## IFB #299-17 CONSTRUCTION SERVICES FOR THE VETERANS MEMORIAL POOL HOUSE

### ADDENDUM #2

**POOL HOUSE**  
VETERAN'S MEMORIAL PARK  
186 RECREATION ROAD  
DAWSONVILLE GEORGIA

**1 POWER RISER DIAGRAM**  
E0.1 NOT TO SCALE

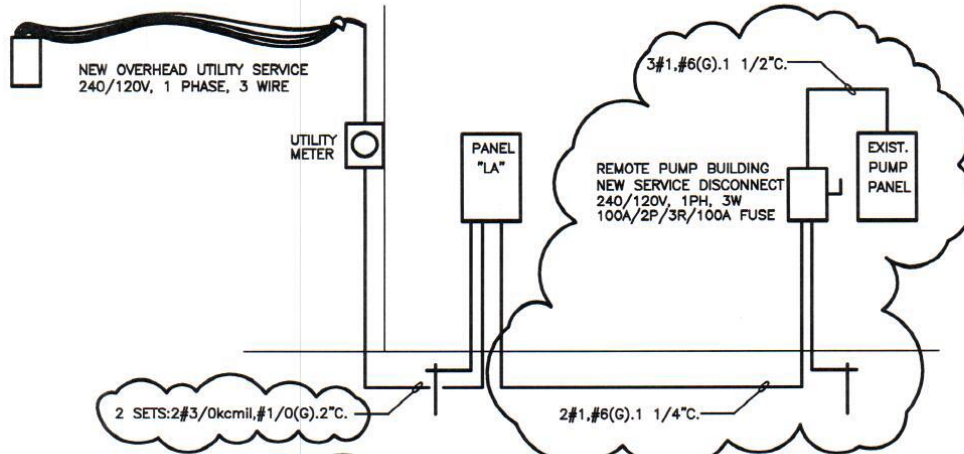
1. The Addendum release date has been extended one day to allow for answer a question in relation to the requirement and sizes of the back flow preventer and related items. Addendum #2 will be released by close of business November 3, 2017.
2. Scope of work has been added to the required work in the IFB document. The attached drawing on page 3 addresses the power to feed pump house and pumps.
3. All other dates, terms and conditions of the IFB remain the same.
